Work Order ID 99066

Item Name: 205 Bent Tube

DRAWING NO. D2580	TITLE 205 SKIDTUBE ASSEMBLY	REV. E	DART AEROSPACE LTD ENGINEERING ORDER	D.E.O. NO. D2580-E-1	SHEET NO. SHEET 1 OF 1	SCALE NTS
DRAWN <i>JP</i>	CHECKED <i>ASS</i>	MFG. APPR. <i>EC</i>	APPROVED <i>[Signature]</i>	DE APPR. <i>[Signature]</i>		
DATE 11.12.13	DATE 11.12.13	DATE 11.12.13	DATE 11.12.13	DATE 11.12.13

CHANGE ALL C'BORED WELDED CROSSBOLT SPACERS TO SWAGED SPACERS

SECTION B-B D5-2
SCALE 5X

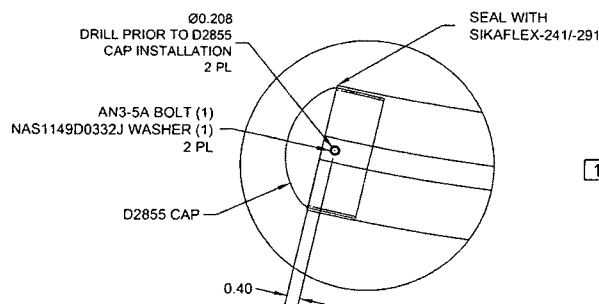
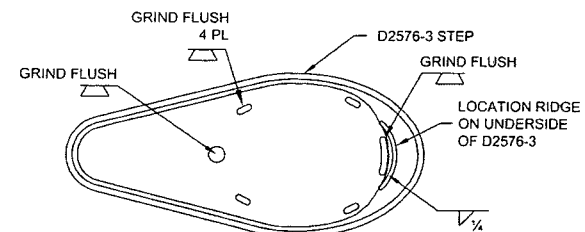
- AFTER DRILLING AND BENDING ASSEMBLY
PERFORM THE FOLLOWING FOR Ø0.508 HOLES ONLY:
1. CHAMFER HOLE 0.050 X 45°
 2. INSERT D2579 SPACER (20 PLACES)
 3. WELD INTO PLACE AND GRIND FLUSH
 4. C'BORE D2579 SPACER TO Ø0.437 X 1.00 DEEP

SECTION B-B, F-F, I-I
NOT TO SCALE

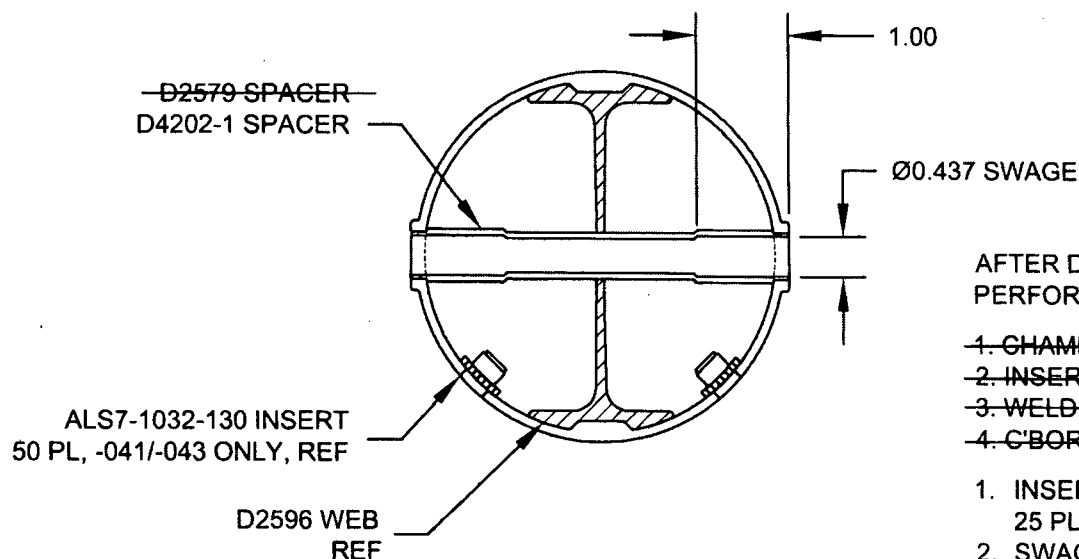
SECTION B-B, SECTION F-F, & SECTION I-I ARE AMENDED AS FOLLOWS
FOR ALL HOLES THAT WERE ORIGINALLY C'BORED:

- ~~1. CHAMFER HOLE 0.050 X 45°~~
- ~~2. INSERT D2579 SPACER (20 PLACES)~~
- ~~3. WELD INTO PLACE AND GRIND FLUSH~~
- ~~4. C'BORE D2579 SPACER TO Ø0.437 X 1.00 DEEP~~

*** FOR -045 SKIDTUBE ONLY:**
WELD 4X D2579 SPACERS PER DWG
IN LOCATIONS MARKED "NO C'BORE".
REF SHEET 4 OF DWG.

1. INSERT D4202-1 SPACER, 20 PL (-041) OR 20 PL (-045) OR 25 PL (-047)
2. SWAGE TO Ø0.437 X 1.00 DEEP PER QSI 002
3. TRIM / GRIND FLUSH PER QSI 002
